Downtown Development Review Overlay (DDRO) District

MEMORANDUM

Case No: 22-OVERLAY-0028

Property Address: 133 W. Market St.

Currently Proposed Design – Main Corner of 2nd & Market

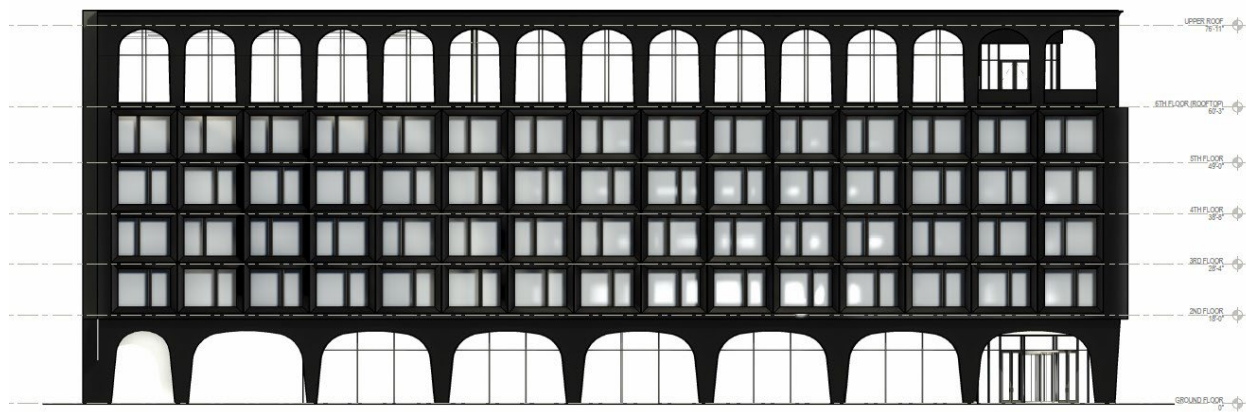
However, there has been a loss of definition for the main corner of the building and defined articulation at the pedestrian street level, that was more discernible in the approved design. The approved design provided visual weight at the corner, through a change in height, slight wall projection, and change in material. This added emphasis and weight clearly identified the main entrance and provided a better spatial relationship with the Convention Center across the intersection. From several vantages, it also helped to break up the overall massing and flat planes of the upper stories.

With the proposed design, the corner is no longer easily discernible from the rest of the building. The height is now uniform across both street-side facades and there is no significant material change. The repetitive arches along the top and bottom continue along the full lengths of each street-side façade, which removes some of the articulation provided by the previously angled walls. While the previously proposed angle visually breaks up the massing and more strongly establishes the corner entrance, the arches at the top and bottom of the building improve the pedestrian experience and result in the building being more dynamic and interesting with varying window forms. The upper arches are slightly stepped back which helps break up the massing along the horizontal. Ultimately, the introduction of the arched openings provides more architectural deviation and makes the building more unique from other buildings downtown. However their

placement along the entire lengths of the façade minimalizes the important corner and establishes a more uniform height. If the changes are approved, attention should be paid to highlighting the corner through other non-architectural means, such as signage, lighting, and/or public art. Entrances should be emphasized with lighting and doorway/storefront features that are distinct from other areas along the ground level. If specific treatments are given in the finishing details, the massing could be better broken up and the corner/main entrance given more emphasis:

8. **Prior to occupancy, finalized design details and materials shall be submitted to Planning and Design Services staff for final review and approval to address the issues with corner of the building and street-facing entrances as described in this report**

Currently Proposed West Façade – 2nd St.

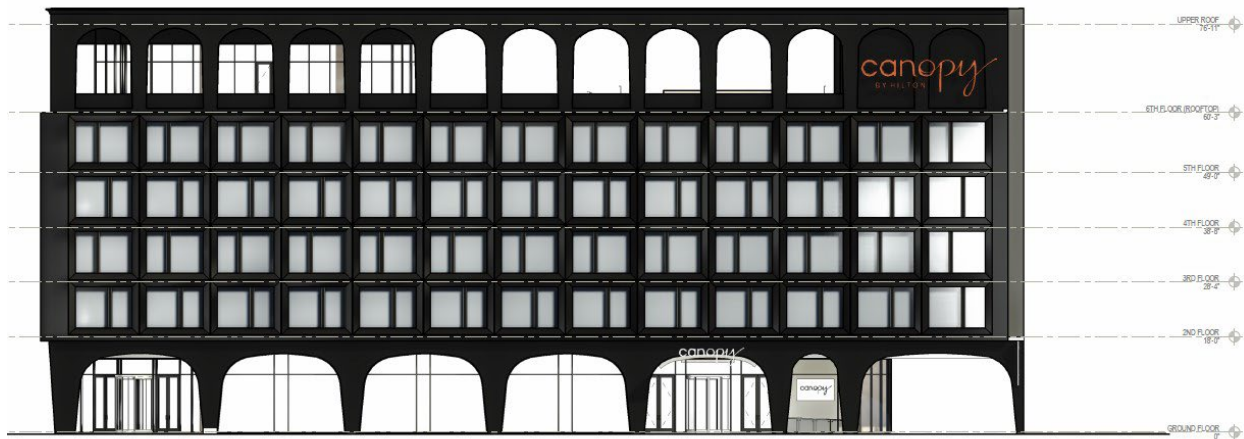
The general massing and height of the building remains relatively the same. The proposed changes introduce a greater amount of storefront glass at the pedestrian level along 2nd and Market Streets. The number of upper story window openings are generally the same, as well as their sizes and proportions; however the top story openings have been modified with arch tops.
